ADDENDUM #1

C-STREET SEWER REHABILITATION

BID #12/13-014 – PWP# WA-2013-096

EXHIBIT B

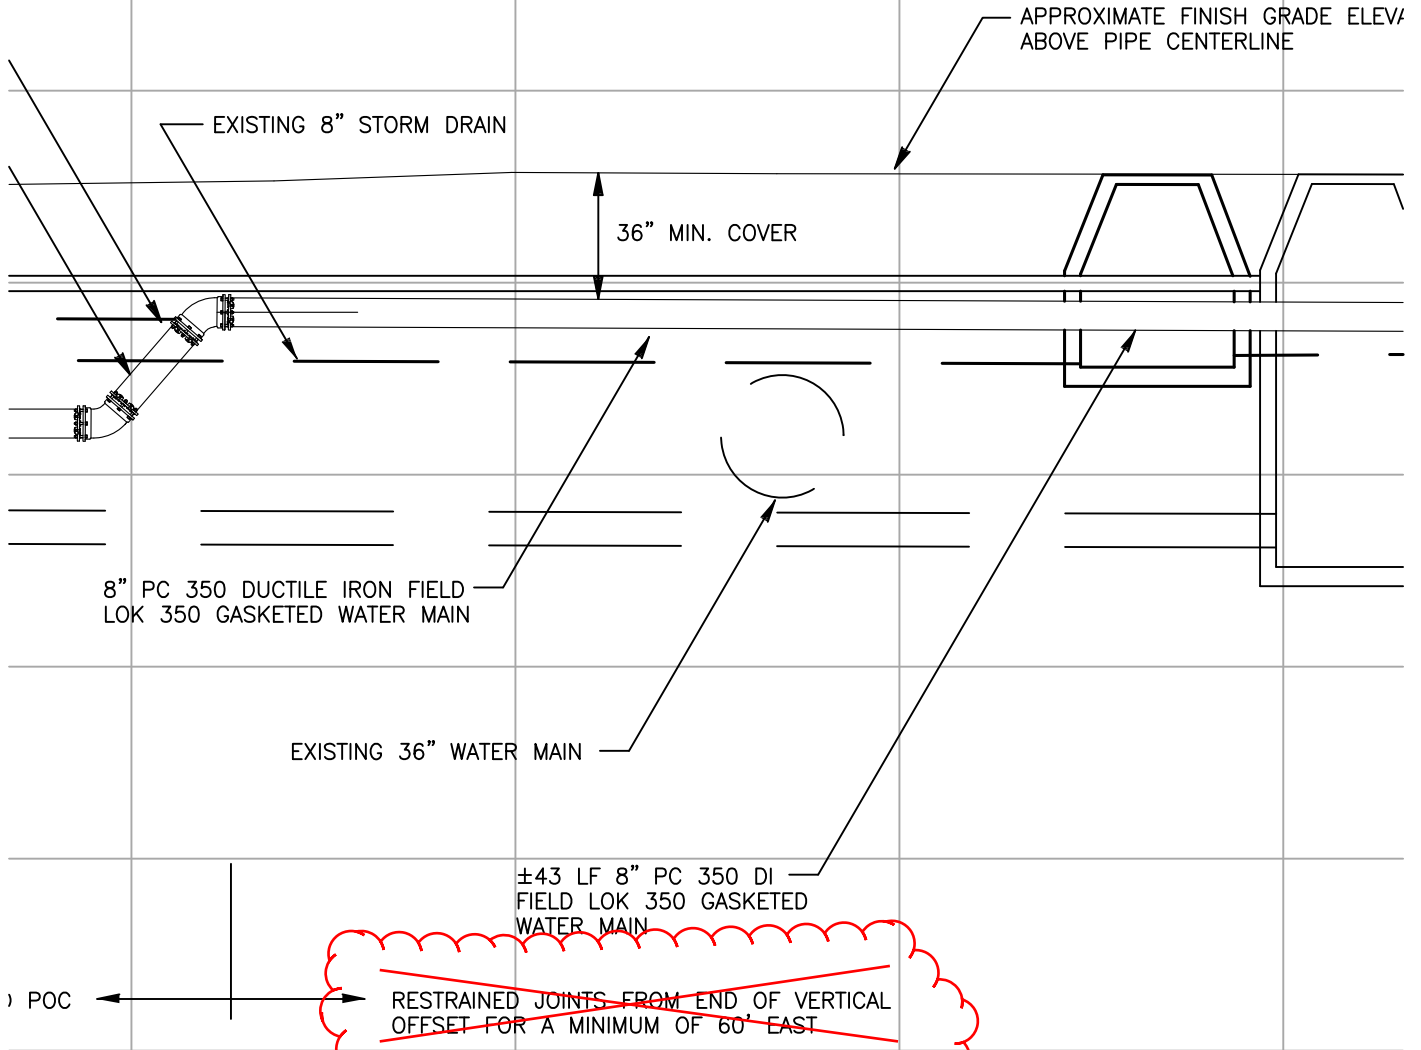
11. Delete note as shown in Exhibit "B" which applies to sheet C-4 of the TMWA plan set.

DELETE THIS NOTE. ALL WATER MAIN PIPE INSTALLED WITH THIS PROJECT SHALL BE WITH RESTRAINED JOINTS
